WLTP-19-06e Revision 1

Cycle / Gearshifting

Status report about the work of the task force on cycle and gearshift issues, amendment proposals for adoption

Available and required power vs speed

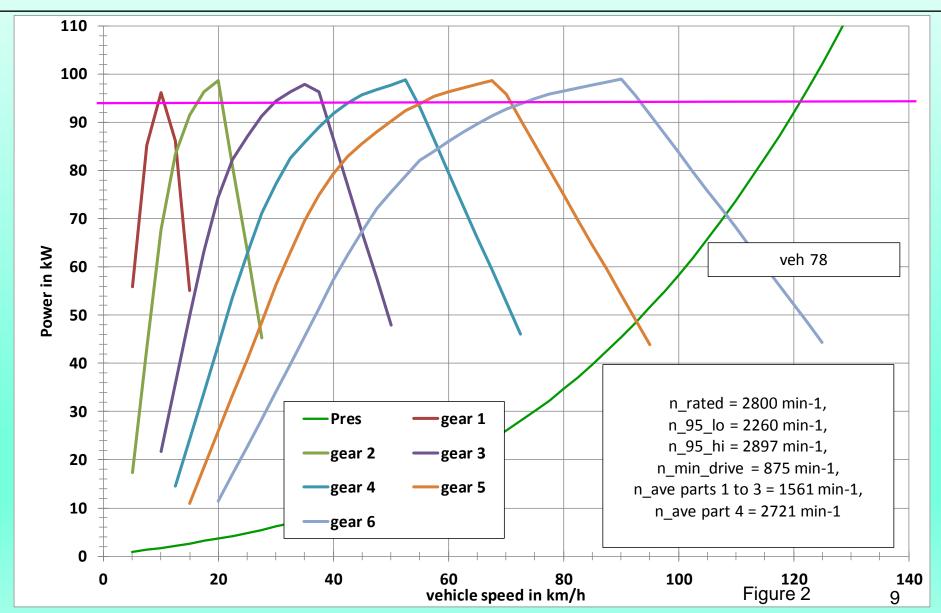
- The Japanese colleagues provided 3 example vehicles for the round robin test of gearshift calculation tools.
- One of these examples (veh 8) could not correctly be calculated with the ACCESS tool (version 31.01.2017) because the design of the full load power curve led to a too low value for $n_{max 95}$ ($n_{95 low}$).
- As a consequence the 2 second rule for acceleration phases (keep a given gear for at least 2 seconds) would lead to higher engine speeds than n_{95 low}.
- The vehicle has an extreme wot power curve with n_{rated} of 2000 min⁻¹, but a usable engine speed range up to 5000 min⁻¹. The vehicle speed at rated engine speed is 63,6 km/h, the engine speed at max. vehicle speed is 4480 min⁻¹.

- The available power for different gears and the required power for constant speed driving are shown in figure 1.
- n_{95_low} is 1893 min⁻¹ (indicated by the pink line parallel to the x-axis); this leads to the fact that the 2. gear can only be used for just 1 second at t = 538 s and at t = 1030 s.
- A similar example is vehicle 78 (a N2 example provided by Japan), whose power curves are shown in figure 2. The 2. gear can only be used for just 1 second at t = 141 s, t = 515 s and t = 1030 s.

- Both cases have an extreme high ratio between the engine speed n_{max}(ng_{vmax}) at maximum cycle speed in ng_{vmax} (the gear in which the maximum vehicle speed is reached) and n_{max 95}.
- This ratio is 2,18 for vehicle 8 and 1,80 for vehicle 78.
 Typical ratios for "normal" vehicles are between 0,65 and 1,25.
- Conclusion: A further requirement needs to be added to paragraph 2 (g) or the current requirements need to be replaced in order to solve this problem.
- The addition of a further requirement is not satifying, because this is then the 3rd time that n_{max_95} needs to be amended in order to eliminate contradictions with the 2 second rule.

Available and required power vs speed

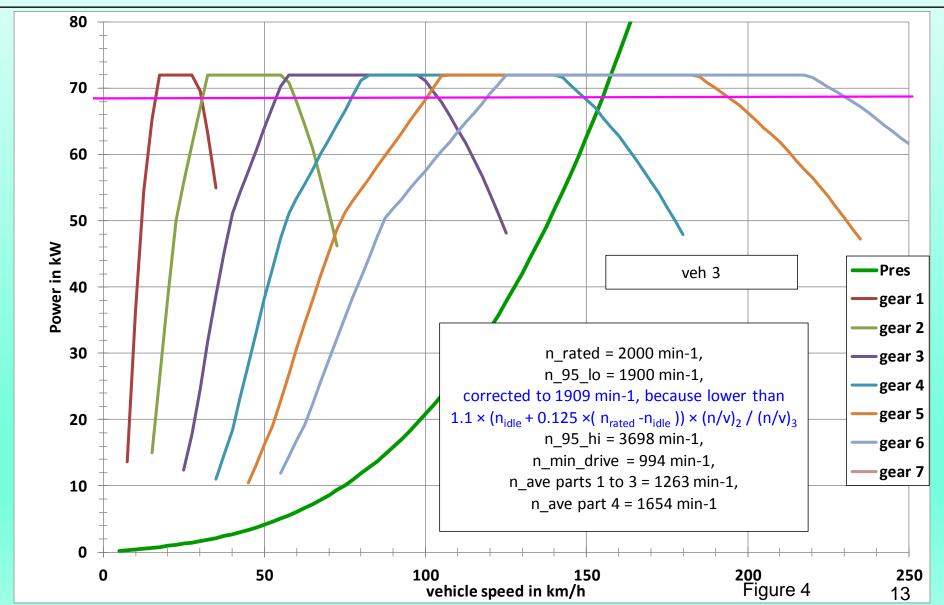
- The following examples make clear that it would be more appropriate to replace the current requirements by a better definition of n_{max_95}.
- Another option would be to skip n_{max} requirements completely.
- Figures 3 and 4 show the available power for all gears and the required power for constant speed driving for two other example vehicles with the same transmission design and almost the same wot power curve.
- The rated engine speed for vehicle 2 is at the upper end of the maximum power plateau (3500 min⁻¹) while the rated engine speed for vehicle 3 is at the lower end (2000 min⁻¹).

- It is obvious that there will be no difference between both vehicles with respect to the driving behaviour in practical use. But the key values for the gearshift calculation are significantly different.
- n_{95_low} is 1900 min⁻¹ in both cases. But 65% of rated engine speed is 2275 min⁻¹ for vehicle 2 and 1300 min⁻¹ for vehicle 3. n_{max_95} needs to be corrected according to para 2 (g) to 65% of rated engine speed (2275 min⁻¹) for vehicle 2 and to 1,1*n_{min_drive}*(n/v)₂/(n/v)₃ (1909 min⁻¹) for vehicle 3.

- ➤ The two additional requirements for n_{max_95}, which were already added in paragraph 2 (g) are obviously not sufficient to cover also such cases.
- A further requirement would need to be added to paragraph 2 (g) or the current requirements need to be replaced in order to solve this problem.
- Proposal for adoption by the IWG:
 - Replace n_{max_95}, which is currently defined as n_{95_low}, by n_{95_high} and amend paragraph 2 (g) as shown in the following slides.

(g) n_{max}

$n_{\text{max}1} = n_{95\text{_high}}$ the maximum engine speed where 95 per cent of rated power is reached, min $^{-1}$;

If n_{max_95} is less than 65 per cent of n_{rated} , n_{max_95} shall be set to 65 per cent of n_{rated} ;

If 65 per cent of $(n_{rated} \times (n/v)_3 / (n/v)_2) < 1.1 \times (n_{idle} + 0.125 \times (n_{rated} - n_{idle}))$, n_{max_95} shall be set to:

Available and required power vs speed

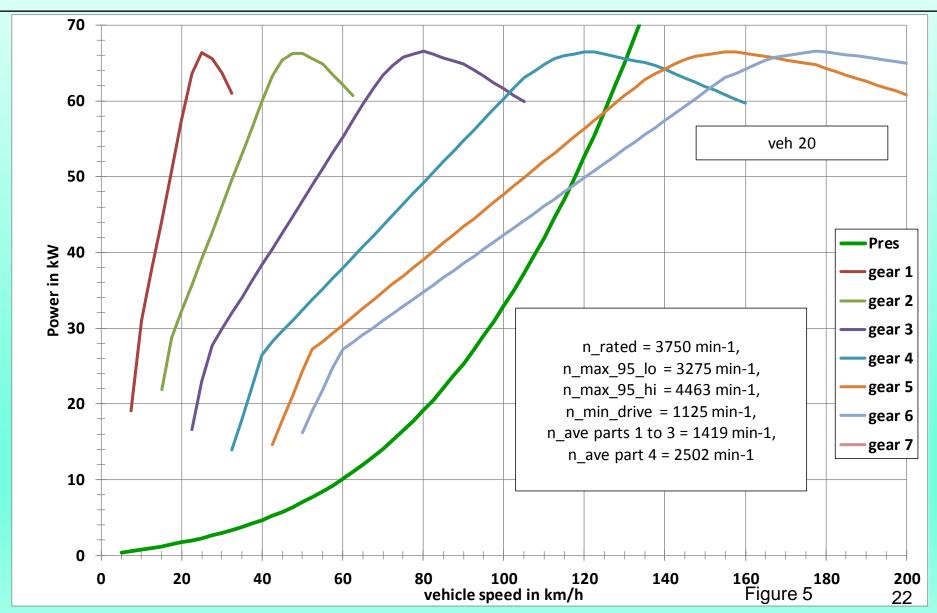
- One of the example vehicles for the RRT have a transmission design, so that the maximum vehicle speed is reached in gear ng-2 (see figure 5).
- This is not covered by the current specifications in paragraph 2 (i).
- In order to cover also gear ng-2 or even lower gears the text needs to be amended as shown in the following slides.
- This proposal is also intended for adoption by the IWG.

ng_{vmax}, the gear in which the maximum vehicle speed is reached and shall be determined as follows:

If
$$v_{max}(ng) \ge v_{max}(ng-1)$$
 and $v_{max}(ng-1) \ge v_{max}(ng-2)$ then, $ng_{vmax} = ng$ and $v_{max} = v_{max}(ng)$,
$$If \ v_{max}(ng) < v_{max}(ng-1) \text{ and }, \ v_{max}(ng-1) \ge v_{max}(ng-2) \text{ then,}$$

$$ng_{vmax} = ng-1 \text{ and } v_{max} = v_{max}(ng-1),$$
 otherwise, $ng_{vmax} = ng-2$ and $v_{max} = v_{max}(ng-2)$ where:

The above described method shall be extended to even lower gears ng-3, ng-4, etc, if necessary.

Condition (3), new proposal vs current

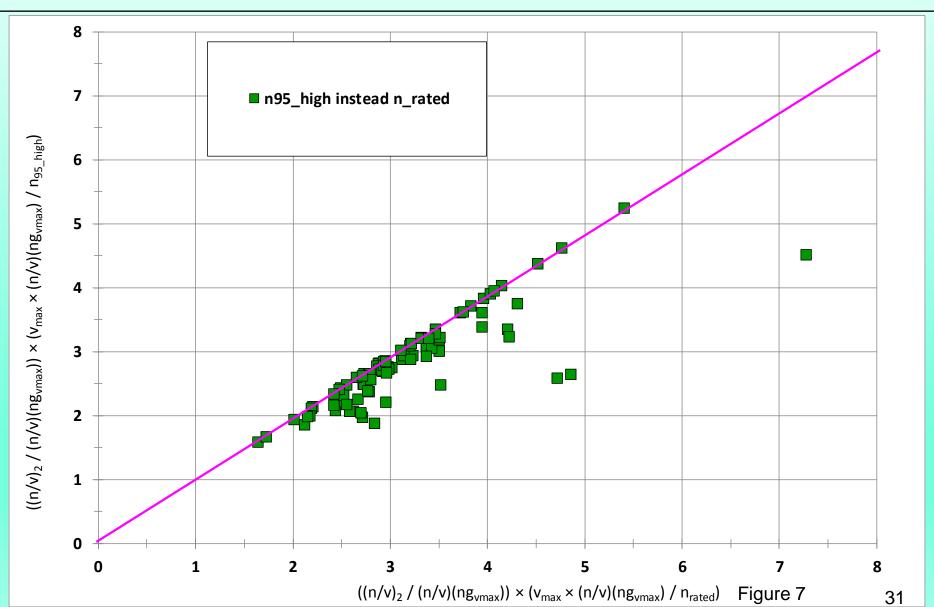
- If n_{95_high} would be used for the calculation of the conditions (3) and (4) instead of n_{rated} the requirements would be improved significantly.
- But then, of course, the threshold values of 7 and 4 need to be adjusted.
- In order to find appropriate thresholds for n_{95_high}, the values resulting from the equations (3) and (4) in slide 27 were calculated for all vehicles in the database for the current situation as well as for the new proposal.
- The results for condition (3) are shown in figure 6, the results for condition (4) in figure 7.

- If one takes the pink curves as basis, the thresholds would be transformed to
 - (3) 7 -> 6,74
 - $(4) 4 \rightarrow 3.85$
- The database contains 8 other vehicles that would qualify for a crawler gear according to conditions (3) and (4), for the current condition as well as for the new proposal.
- None of these vehicles showed driveability problems, when the 1. gear was disregarded for the gear use calculation.

(3)
$$(n/v)_1 \times (v_{\text{max}} / n_{95_\text{high}}) > 6,74$$

(4)
$$(n/v)_2 \times (v_{\text{max}} / n_{95_\text{high}}) > 3.85;$$
